SERVICE BULLETIN

No. 751

Piper Aircraft Corporation

Subject: Spar Cap Chafing Inspection

LEFT SIDE SHOWN, RIGHT SIDE OPPOSITE

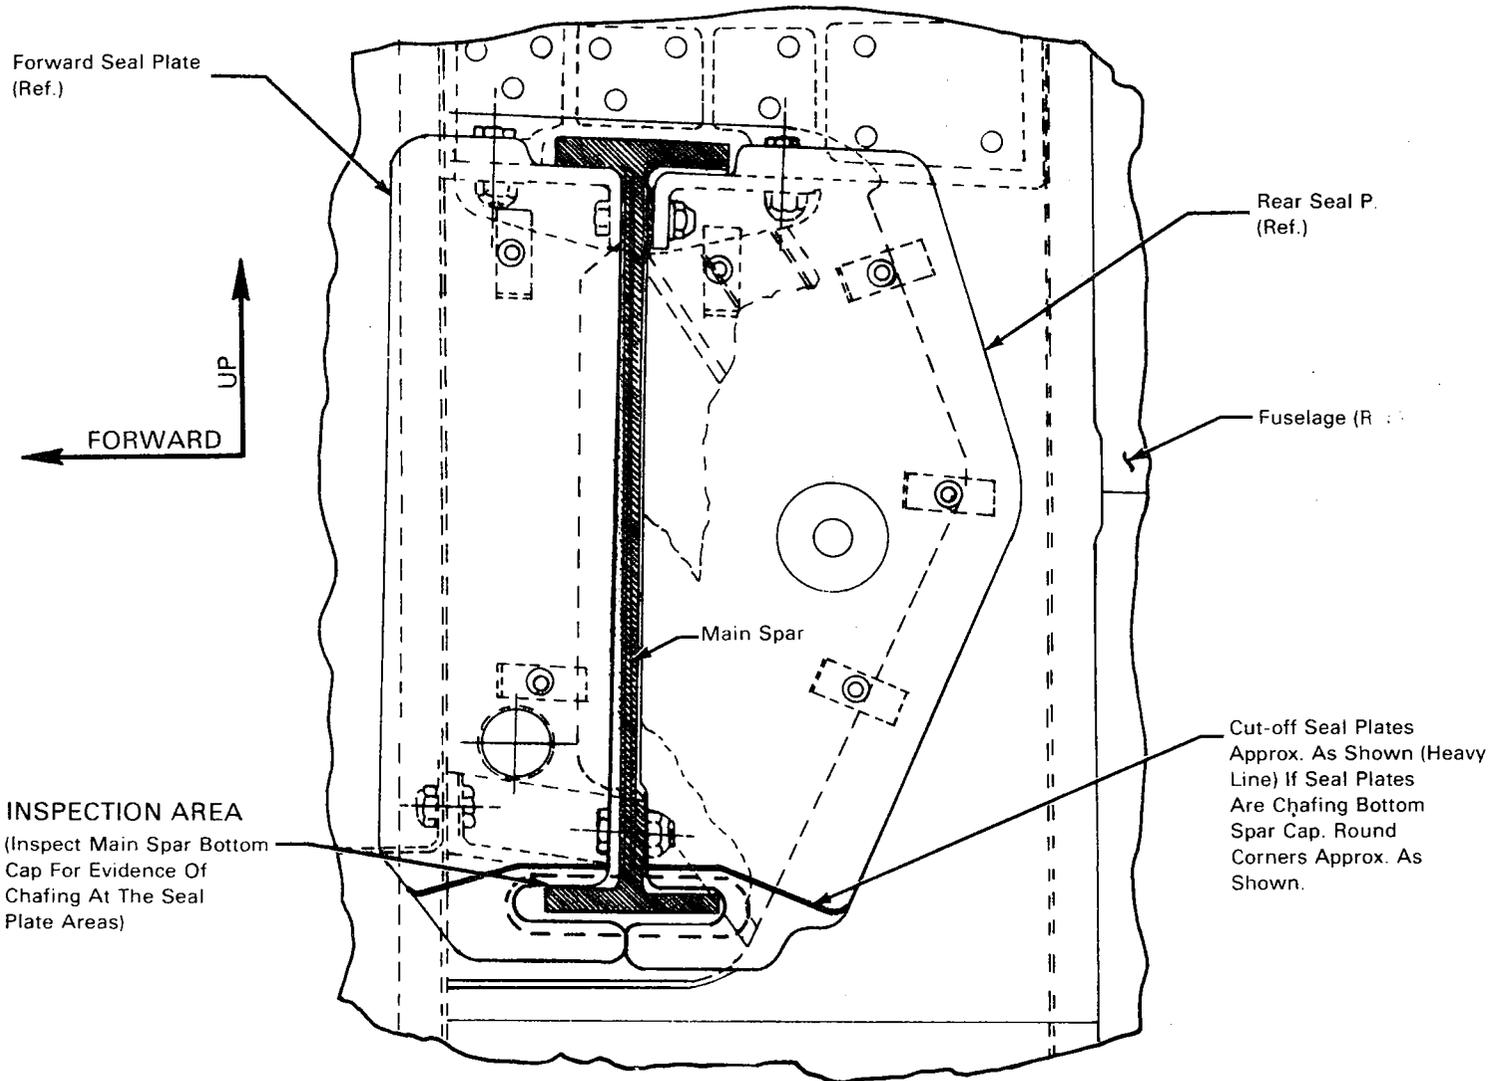
1. Obtain access to the affected area of the lower spar cap by removing the lower wing root fairing.
2. With reference to the attached sketch, trim off the lower portion of each seal plate using a pair of aviation sheet metal shears.
3. Visually inspect both the upper and lower surfaces of the bottom spar cap where it passes through the seal plates. A mirror and flashlight will be necessary to properly inspect the upper surface. If no chafing is found, no further action is required.
4. If chafing is evident, perform a dye penetrant check of the chafed area. Provided no cracks are found, the chafed area should be polished to a smooth contour with progressively finer grades of "wet or dry type" emery paper. Final polishing should be accomplished with a 400 or 600 grade paper. The depth of the contoured area after smoothing and polishing
